DATE 7-26-61 SHOF		TMC	SPECIFICATION NO.	<b>S-</b> 592	A
LB L6	TITLE:	SYNTHESIZ	ZED GPT-10K and GPT-40K ALDC	JOB	
APPR VED		MODIFICAT	TION KIT (TMC NO. KIT-112)

To provide ALDC from transmitter to exciter units in auxilliary frame.

AX-113, MAIN POWER PANEL CHANGE WIRING OF ALDC SWITCH S1003 PART NO. SW-255

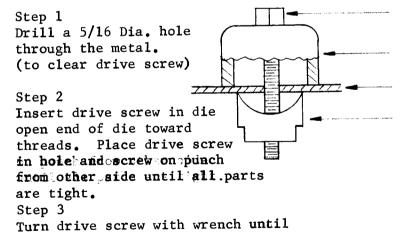
- 6. Rewire ALDC switch, symbol No. S1003, as per Figure 2.
- 7. Referring to Figure 3, Drilling Plan, Auxilliary Frame Center Panel, MS-2469, mark location of new "D" hole. Drill a 5/16 dia. hole with item 5. Punch a "D" hole with item 4.

VIEWED FROM REAR OF PANEL (SHOWN IN "ON" POSITION)
